# SERVICE BULLETIN

## REPLACEMENT OF FUEL PRESSURE REGULATOR ASSY. PART NO. 887130 FOR ROTAX® ENGINE TYPE 914 (SERIES) SB-914-040 UL

## REPLACEMENT OF FUEL PRESSURE REGULATOR ASSY. PART NO. 887130 FOR ROTAX® ENGINE TYPE 914 (SERIES) SB-914-040

**Fig. 1**

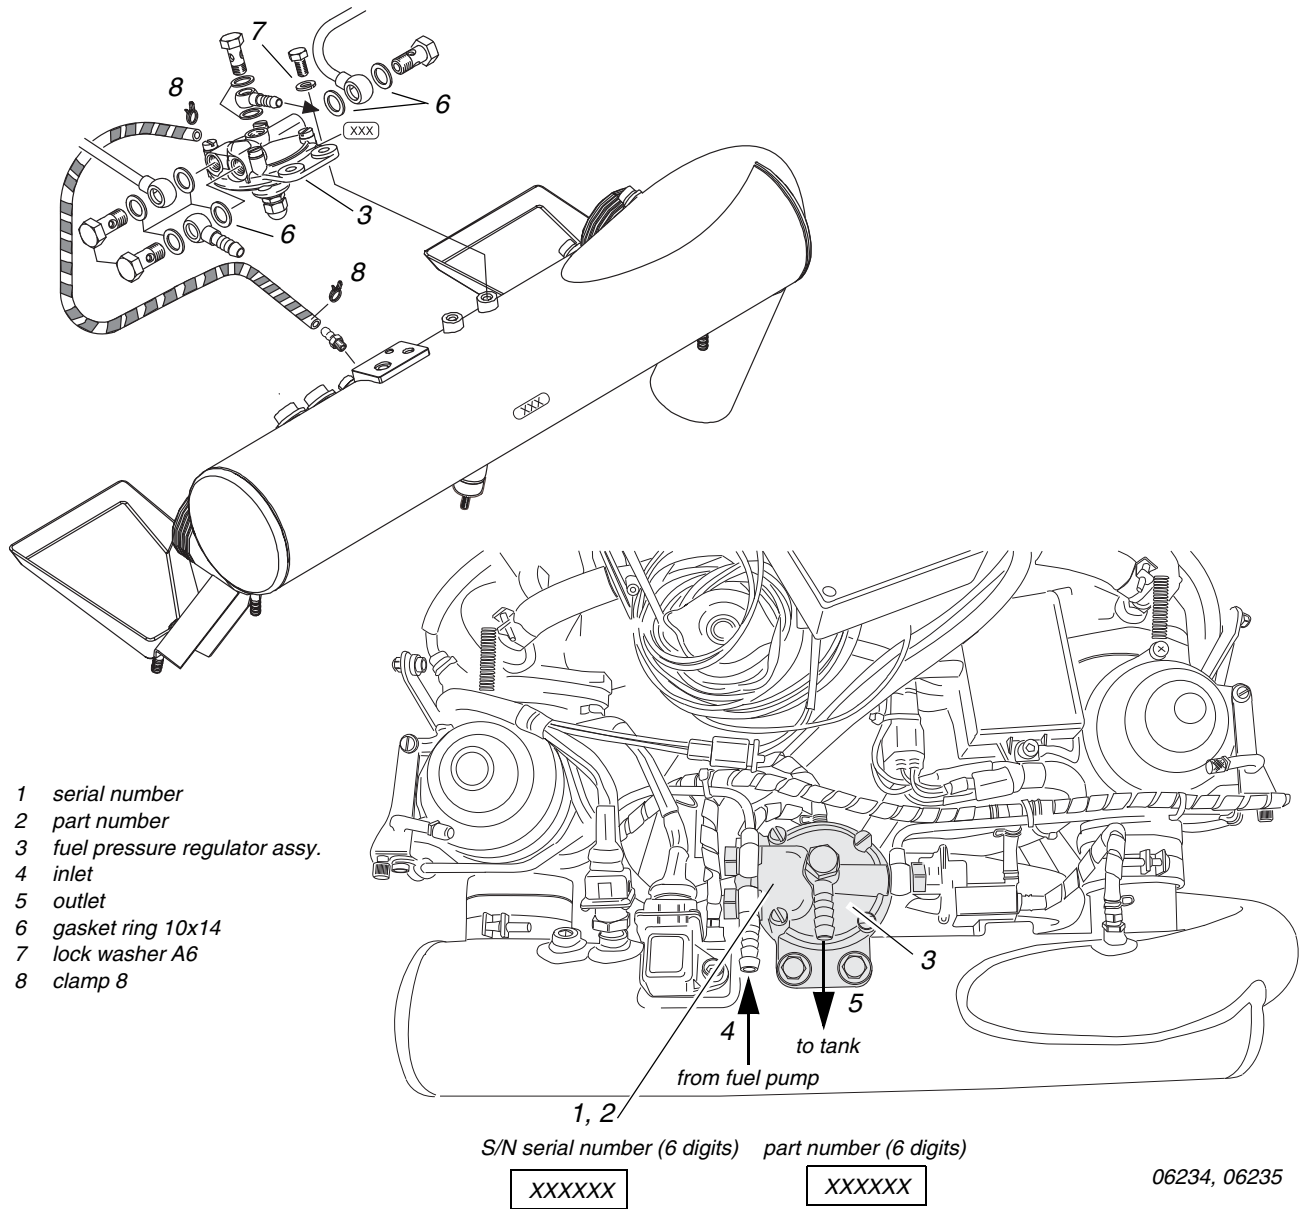
- ◆ **NOTE:** The corresponding serial number (1) and part number (2) is visible on the flange of the fuel pressure regulator assy. (3) (see fig. 1).

Isolated manufacturing deviations at the threads of the fuel pressure regulator could result in slightly leaks in the area of the banjo bolt for the fuel return to tank.

1. Visual check of the pressure regulator assy. (3).
2. Fuel pressure regulator assy. disassembly in accordance with the relevant Maintenance Manual.
3. Fuel pressure regulator assy. assembly in accordance with the relevant Maintenance Manual.

1. Check the correct fuel pressure (approx. 250 hPa above the airbox pressure). If necessary, adjust the fuel pressure in accordance with the relevant Maintenance Manual.
